Westinghouse  
Electric Corporation

NSD-NRC-97-5031  
DCP/NRC0792  
Docket No.: STN-52-003

SUBJECT: INFORMAL CORRESPONDENCE

Please find enclosed a formal transmittal of correspondence we have previously sent to you informally. This informal correspondence was sent over the period March 11, 1997 through March 27, 1997.

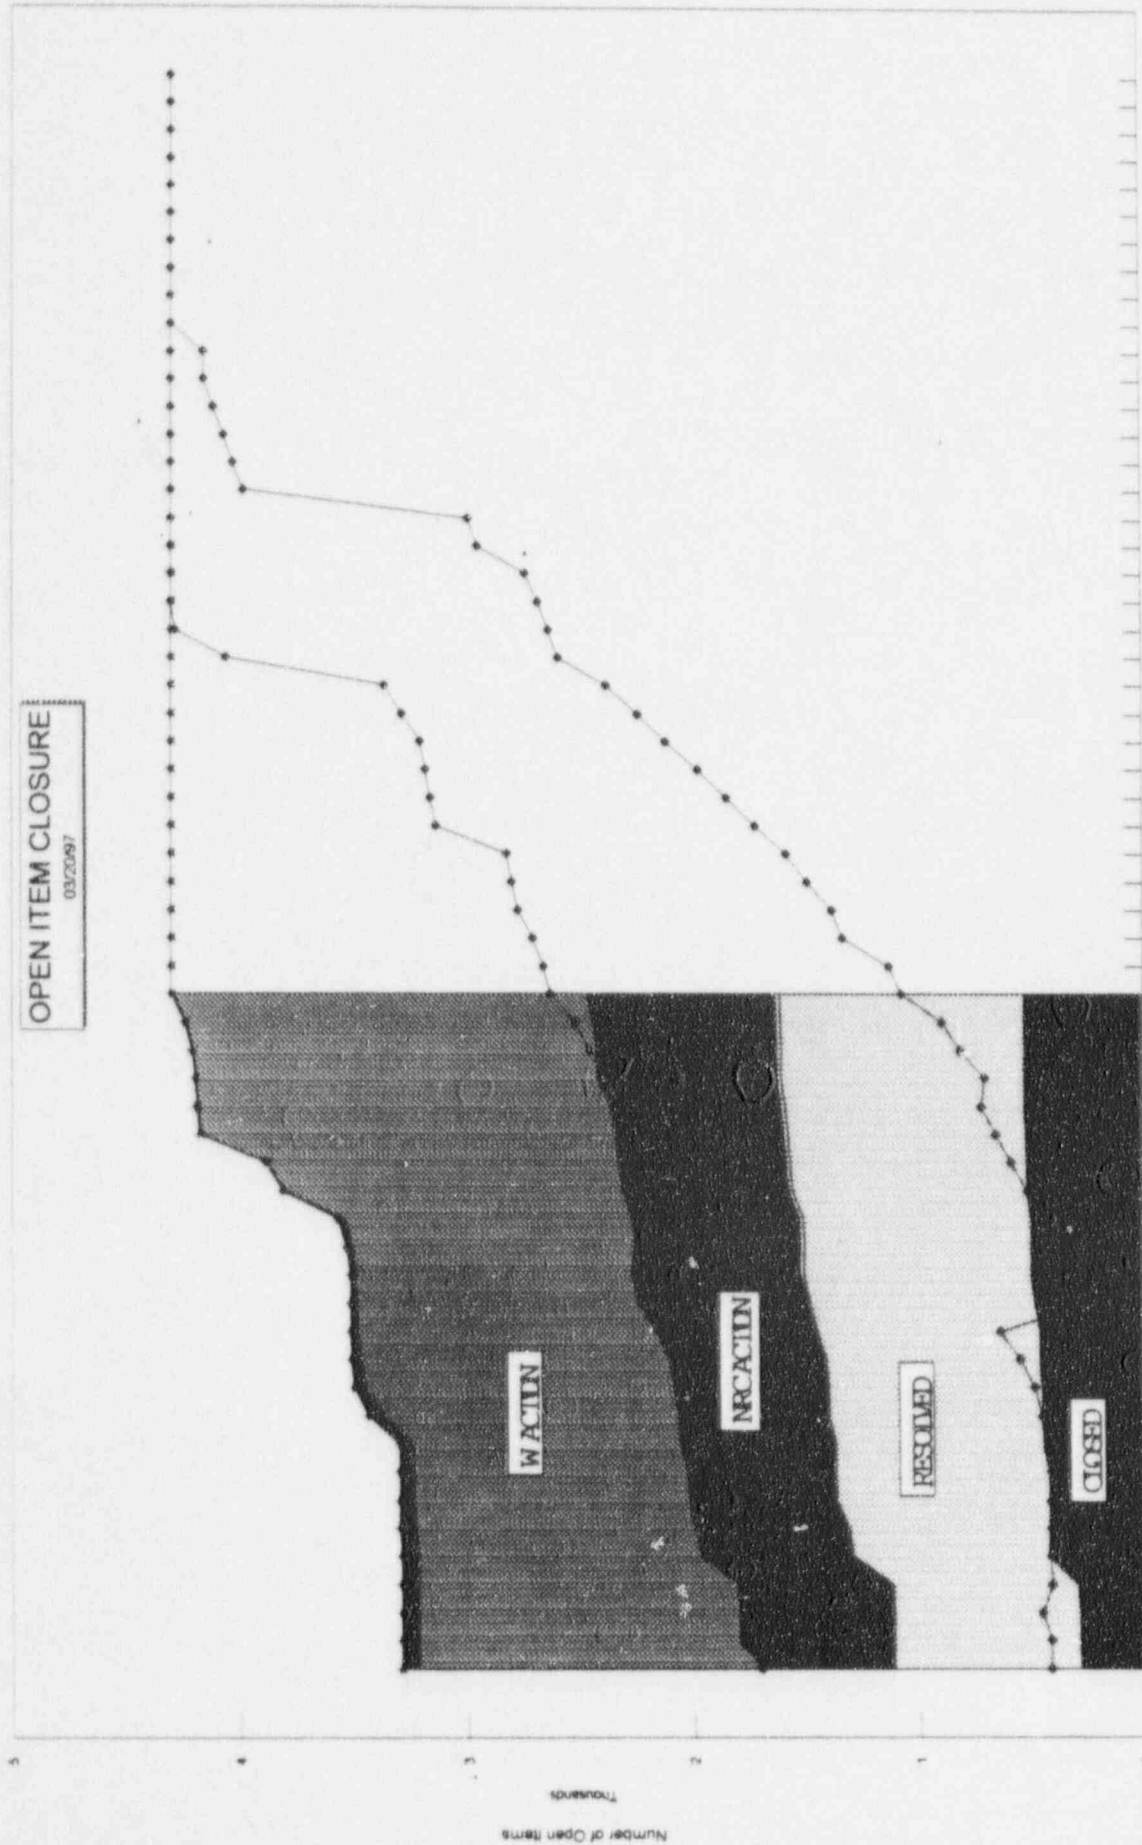
*REVISE ITEM NUMBER 9b (formally item 8b) TO BE AS FOLLOWS:*

9. b) The PMS two-out-of-four initiation logic reverts to two-out-of-three coincidence logic if one of the four channels is bypassed. The PMS automatically produces a reactor trip or engineered safety feature initiation upon an attempt to bypass more than two channels of a function that uses two-out-of-four initiation logic.

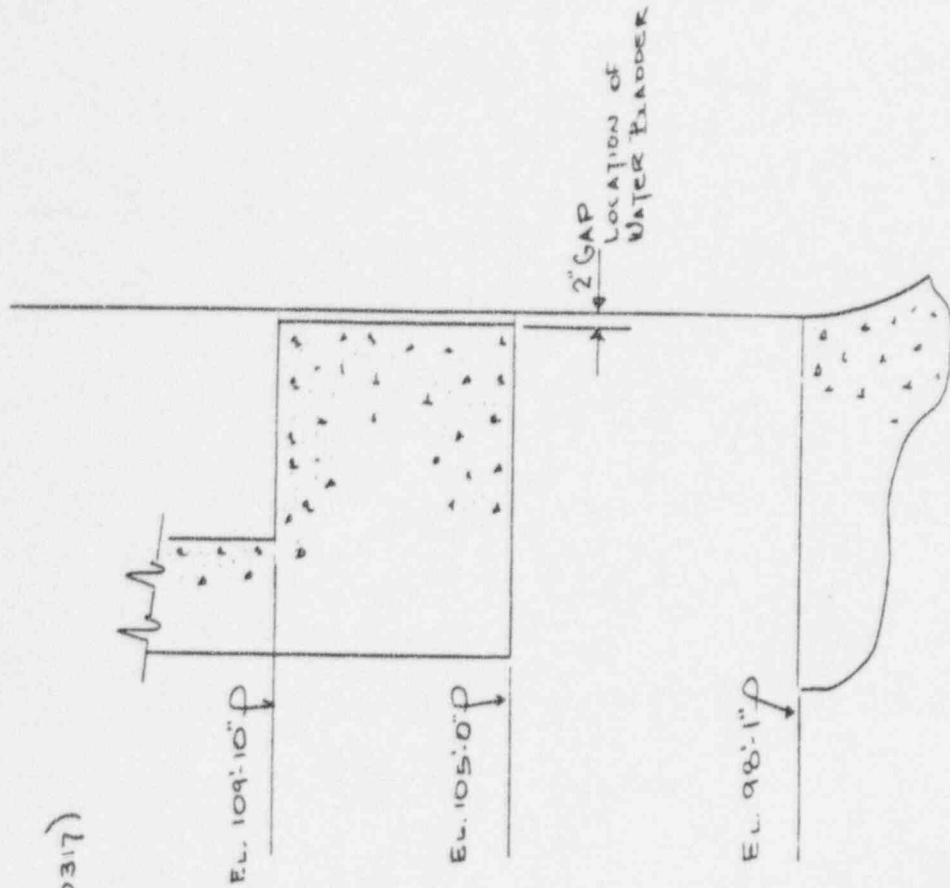
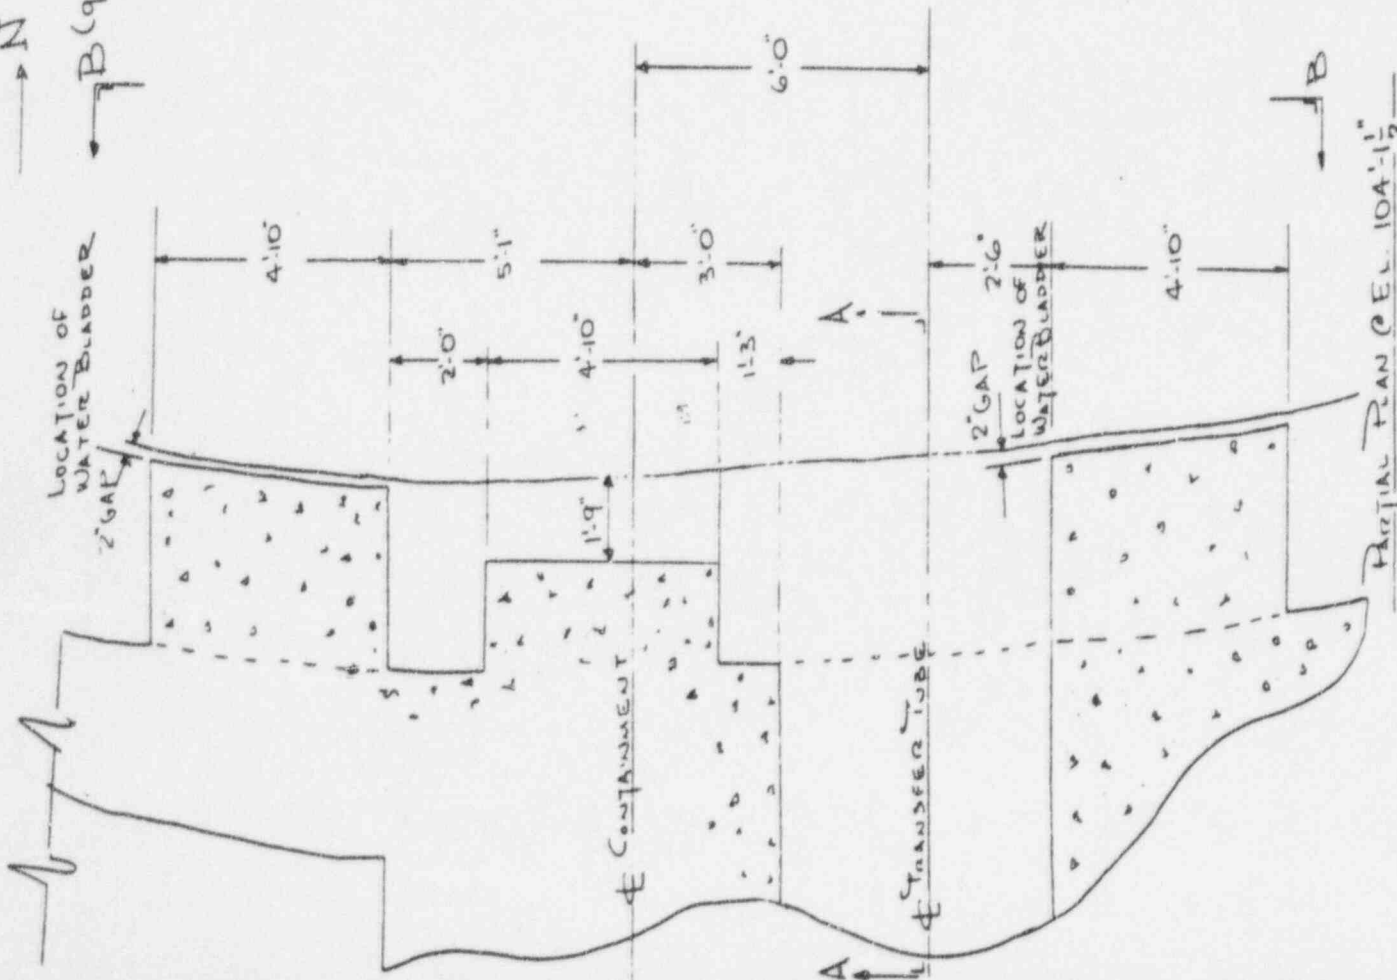
The water-filled bladders will provide shielding in this area during fuel transfer and will accommodate relative movement between the containment and the concrete transfer tube shielding during reactor operation. The location of the water-filled bladders is shown on Sketch 970312, and outline Sketches 970313 and 970317 shows the size and configuration of the bladders.
